Interested Party:	KIA	No.:	1
Subject:	Culverts

Memorandum

SUBJECT: Supplemental Information on Rascal Stream Realignment: Geomorphic Assessment of
Rascal Stream West

Rascal Stream West Channel Stability Assessment

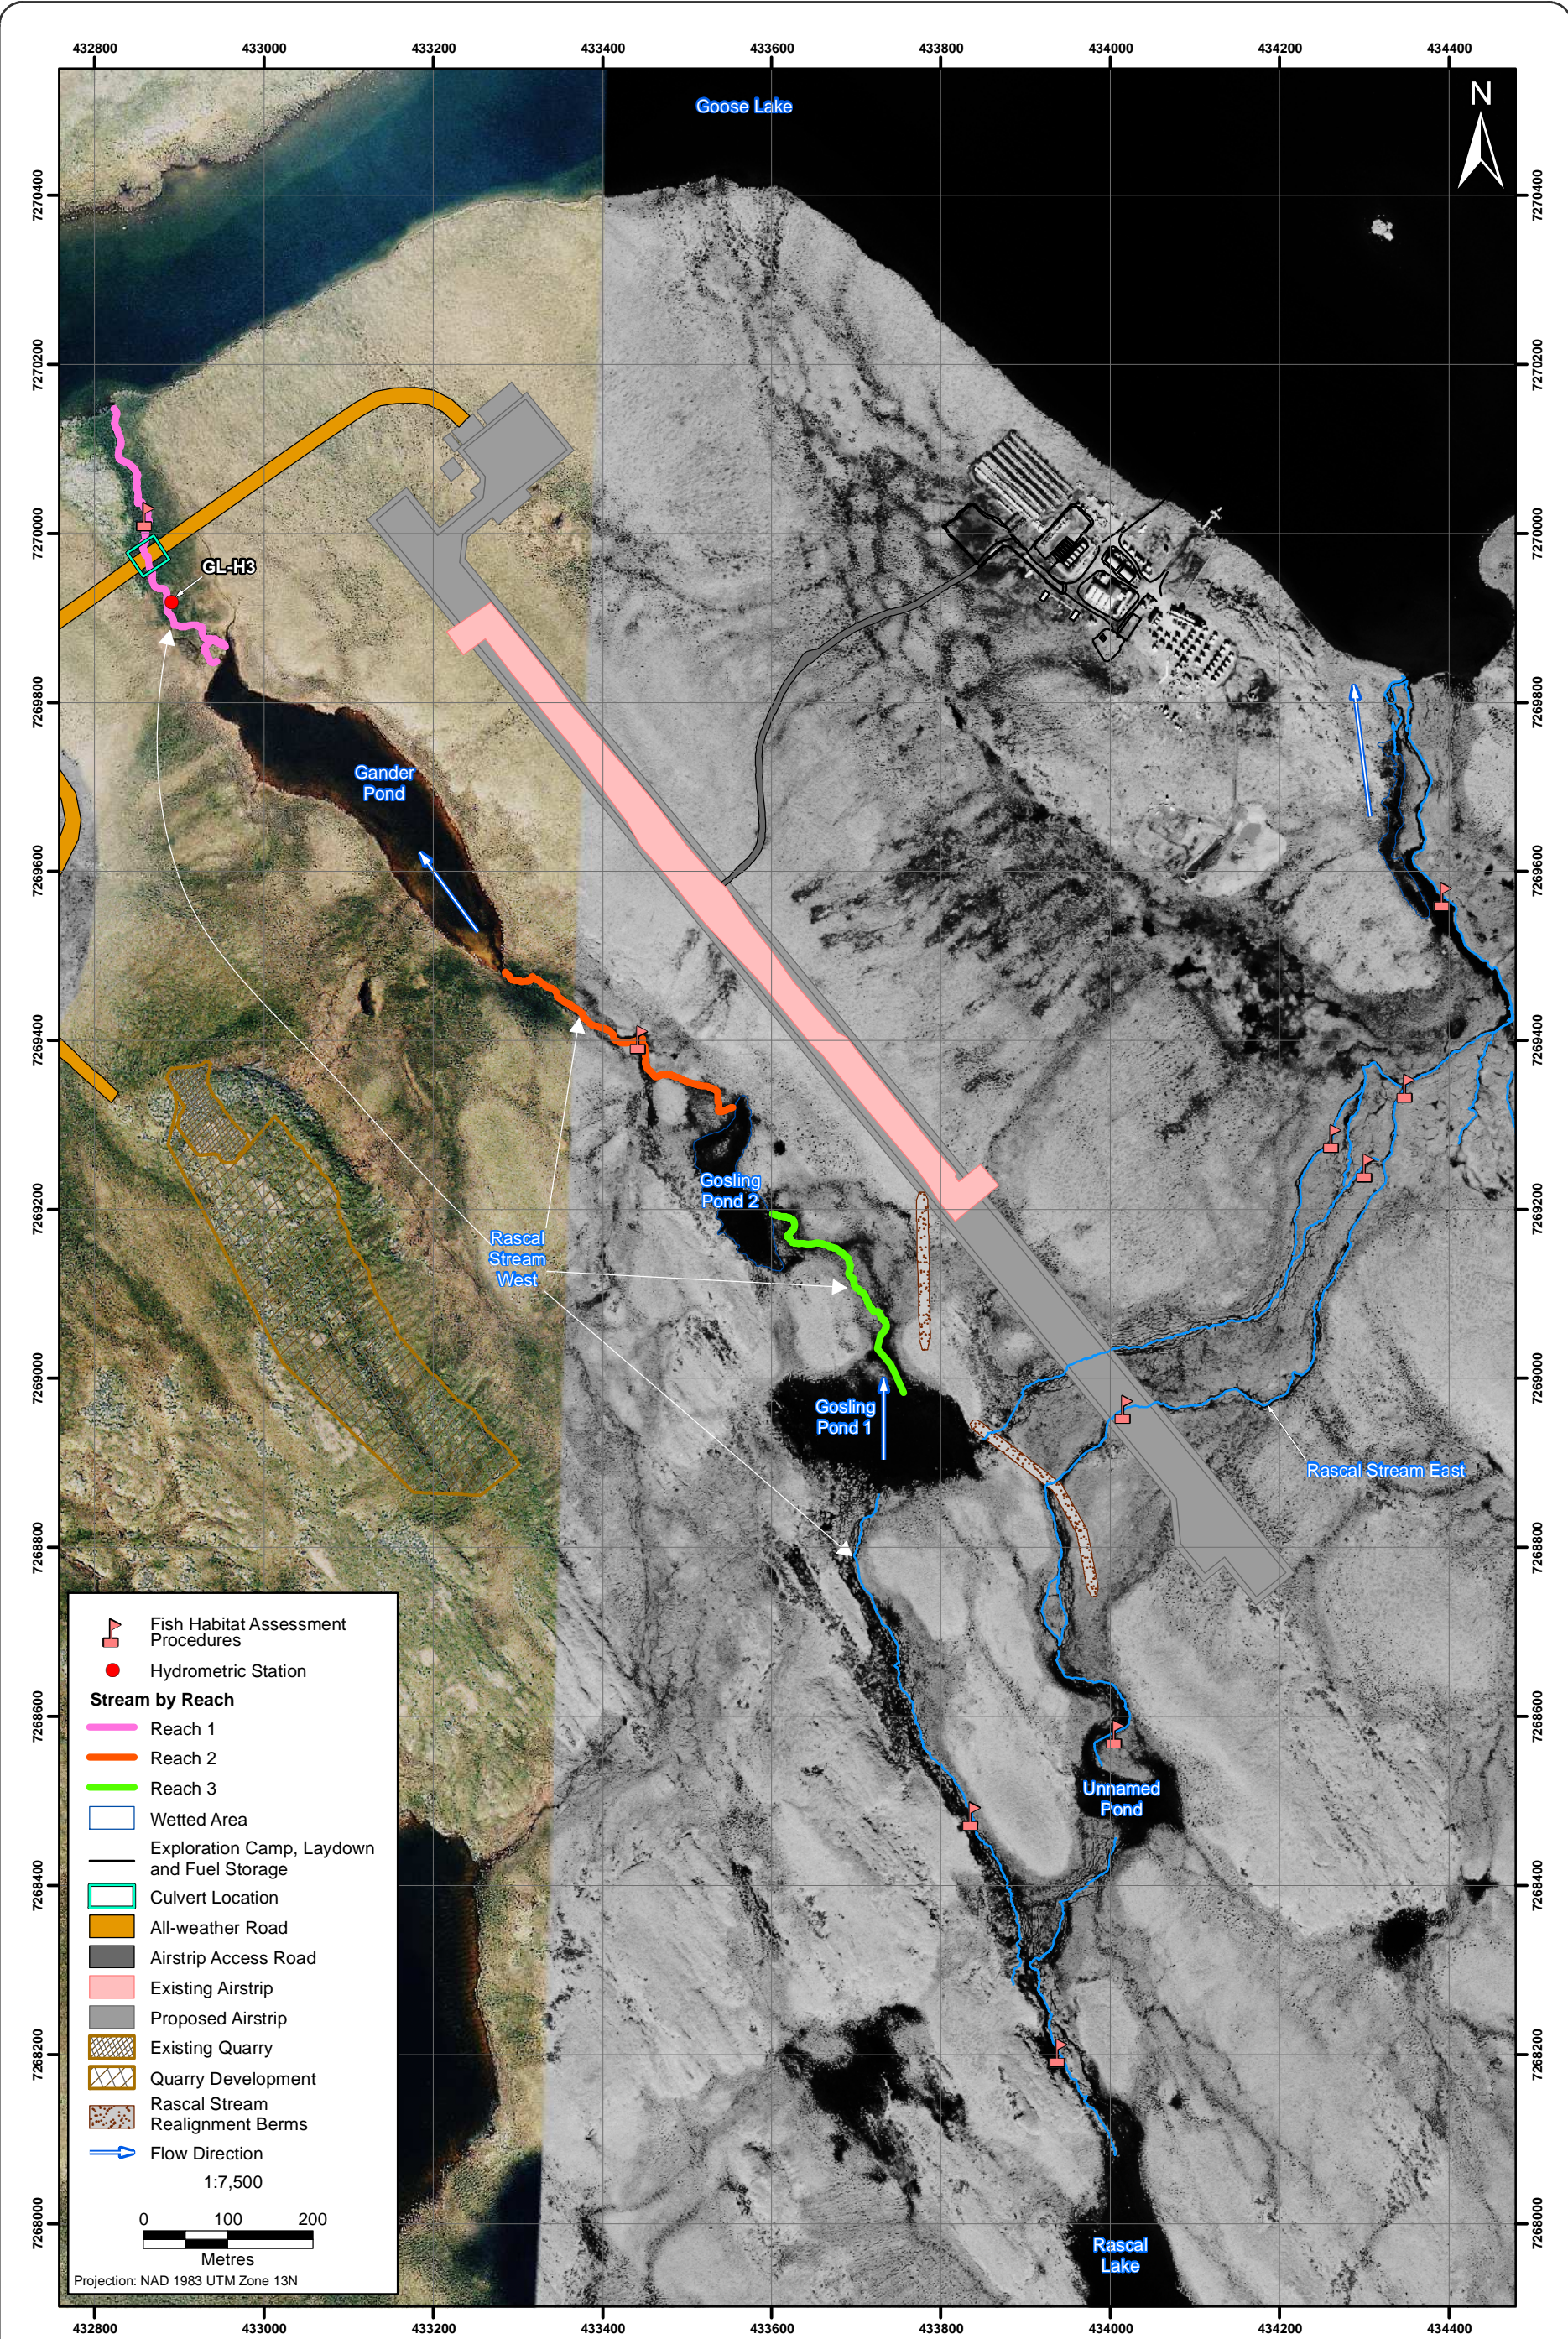
Please indicate whether or not the stream realignment design was approved by a qualified fluvial geomorphologist. At a minimum, we recommend a simple erosion analysis should be completed to assess how the new flow regime will compare to the existing one, in terms of erosion potential.

Channel stability and erosion potential was assessed on Reaches 1 and 2 of RSW (Figure 1; Plates 1, 2). Reach 3 is the area between Gosling Pond 1 and 2, and this area was not included in the modelling as the area is not channelized and hence there are no pre-existing field data. Reaches 1 and 2 of RSW had fisheries assessments conducted on them during the 2013 field seasons (Rescan 2014) and therefore contained the data required to conduct desktop RGAs to assess channel stability and erosion potential.

Reach 1 is the Gander Pond outflow stream and Reach 2 is the Gander Pond inflow stream (Figure 1). During the 2013 fisheries assessment of RSW for the airstrip realignment (Rescan 2014), standard Fish Habitat Assessment Procedures (FHAP) were performed on Reaches 1 and 2 of RSW. Data inputs for the RGAs and the simplified hydraulic model, to supplement the RGAs, were obtained from these FHAP assessments, the surface hydrology field program (various hydrology baseline reports; see the DEIS for the baseline reports; Rescan 2013) and the SRK hydraulic study conducted to support the fisheries assessment (see Appendix 2.1 in Rescan 2014).

The assessment approaches estimated that both Reach 1 and Reach 2 of RSW contained some degree of channel instability and erosion potential (Table 5). It should be acknowledged that these assessments were desktop assessments based on existing field data. Not all field data were perfectly suited to the assessment models. In these cases professional judgement was required to estimate values.
